RE: Review Response Letter – Mill Creek Brewery

We would like to thank you for the recent reviews of the Mill Creek Brewery Project located at 8180 Main Street in Dexter. We have reviewed the Carlisle Wortman and Associates review letter dated February 25, 2022, and the OHM Advisors review letter dated February 22, 2022. We offer the following responses to the comments:

NOT FOR CONSTRUCTION
PLOOR PLAN
SOURCE
21-414
A 130

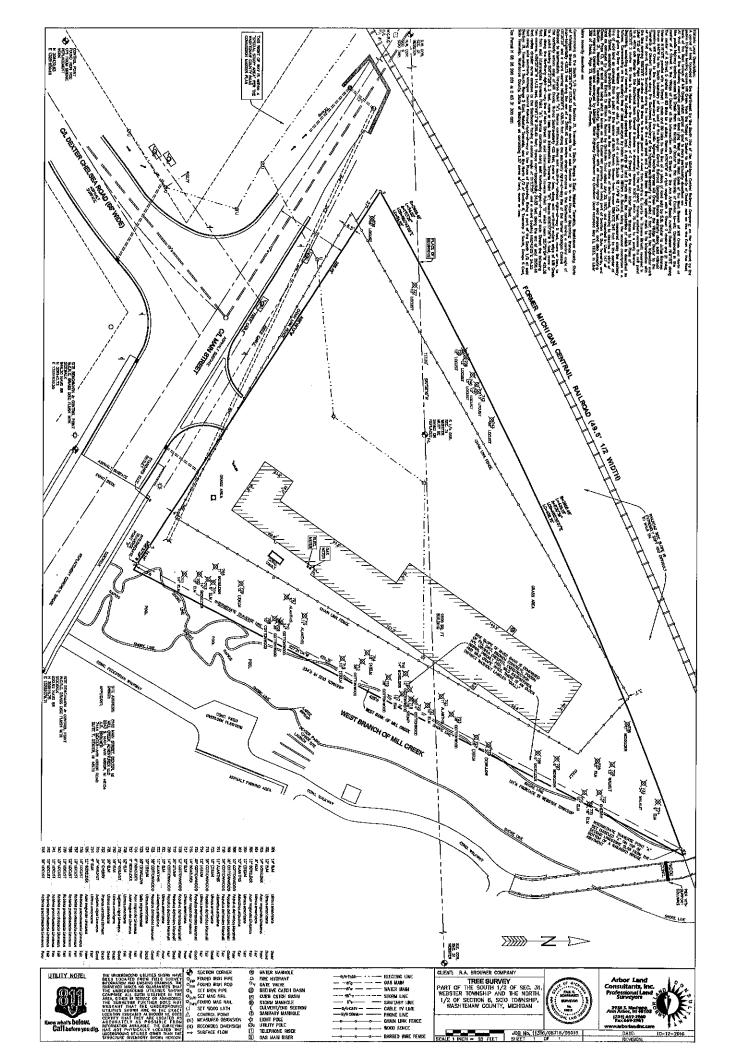
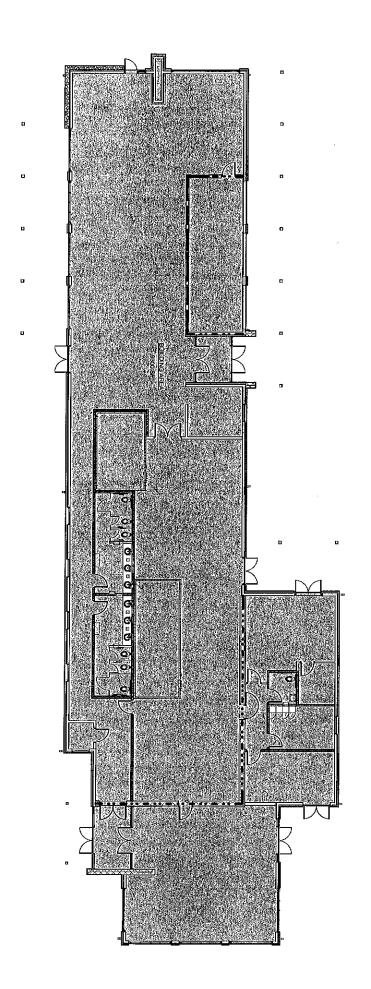
2. Verify size of proposed building.

7. Identify the location of water outlets for landscape maintenance.

The building size is 9300 SF as shown on the Cover Sheet and the attached floor plan.

See Kitchen Layout plan, there are two hose bibs identified, one on the east and one on the west side of the building.
